This letter is in response to your request for Federal Highway Administration (FHWA) acceptance of a modification to Nucor Steel Marion roadside safety systems for use on the National Highway System (NHS).

Name of system:	Nu-Cable Systems – Use of Plastic or Steel Sockets Use of driven steel sockets
Type of system:	Cable Barrier
Test Level:	NCHRP Report 350 TL-3 and TL-4
Testing conducted by:	Holmes Solutions of New Zealand and Texas Transportation Institute
Date of request:	July 25, 2006

- To prevent misunderstanding by others, this letter of acceptance is designated as number B-183 and shall not be reproduced except in full. This letter and the test

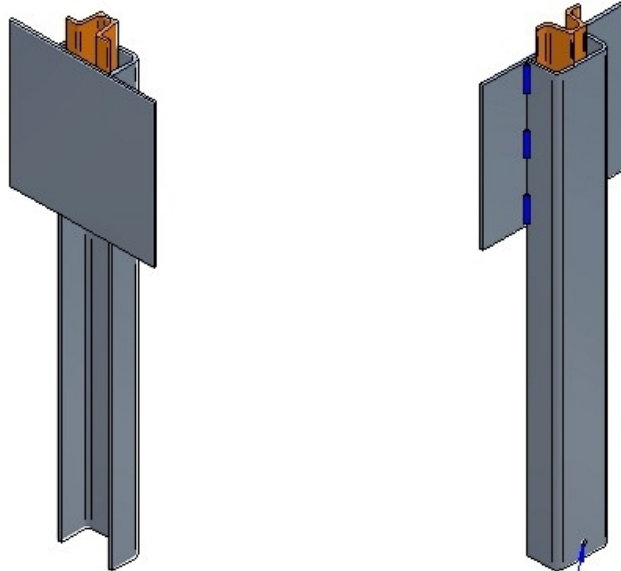
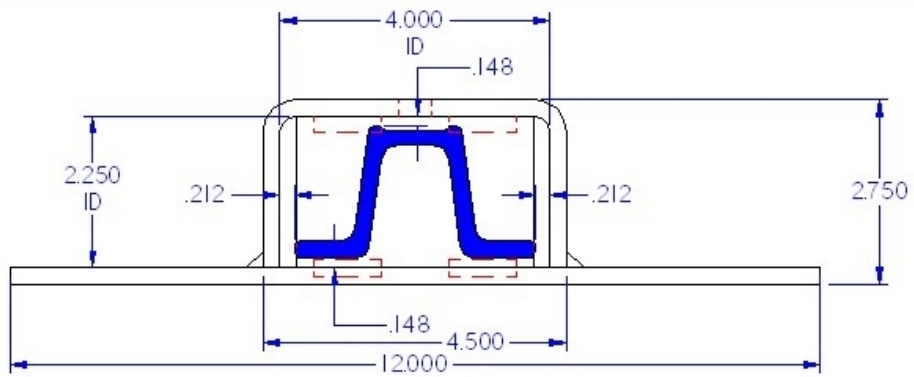
You also requested the use of driven steel socket sleeves for 4-pound-per-foot u-channel posts, as shown in the enclosed drawing. Informal vehicle testing in standard soil showed no perceptible movement of the socket.

- 1) Posts mounted in plastic socket sleeves encased in a rebar fortified concrete foundations,
- 2) Posts mounted in steel socket sleeves encased in a rebar fortified concrete foundations,
- 3) Posts mounted in driven socket sleeves with soil plates.
